Access Compliance Report Public Rights-of-Way (Pedestrian Signals)

Main Street: CROWN_VALLEY_PKWY Cross Street: CROWN_VALLEY_PKWY Location: NE

ADA ID: SGRK211026115754 Signal Type: One Push Button-Non APS Overall Compliance: No Severity Scores: BTN 1: 55 BTN 2: N/A No BTN: N/A

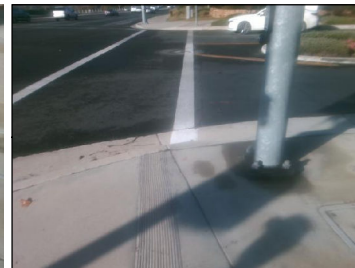
N/A B 1 FWD Approach Obstruction?		N/A	N/A	B 2 FWD Approach Obstruction?	N/A
N/A B 1 FWD Approach Obstruction Dist (in)		N/A	N/A	B 2 FWD Approach ObstructionDist (in)	N/A
N/A B 1 PARA Approach?		N/A	N/A	B 2 PARA Approach?	N/A
N/A B 1 PARA Approach Constrained?		No	N/A	B 2 PARA Approach Constrained?	N/A
Yes B 1 PARA Approach Reach (in)		0	N/A	B 2 PARA Approach Reach (in)	N/A
N/A B 1 PARA Approach Width (in)		N/A	N/A	B 2 PARA Approach Width (in)	N/A
N/A B 1 PARA Approach Obstruction?		No	N/A	B 2 PARA Approach Obstruction?	N/A
N/A B 1 PARA Approach Obstruction Dist (in)		N/A	N/A	B 2 PARA Approach Obstruction Dist (in)	N/A
Yes B 1 Clear Floor Space Slope (%)		2.8	N/A	B 2 Clear Floor Space Slope (%)	N/A
No B 1 Clear Floor Space XSlope (%)		3.5	N/A	B 2 Clear Floor Space XSlope (%)	N/A
N/A B 1 PAR Slope (%)		3.1	N/A	B 2 PAR Slope (%)	N/A
No B 1 Height (in)		49	N/A	B 2 Height (in)	N/A
Yes B 1 Pressure (#)		5	N/A	B 2 Pressure (#)	N/A

Possible Solutions: Replace Signal Push Button With APS Button. Adjust Signal Button Height. Remove and Replace Clear Space.
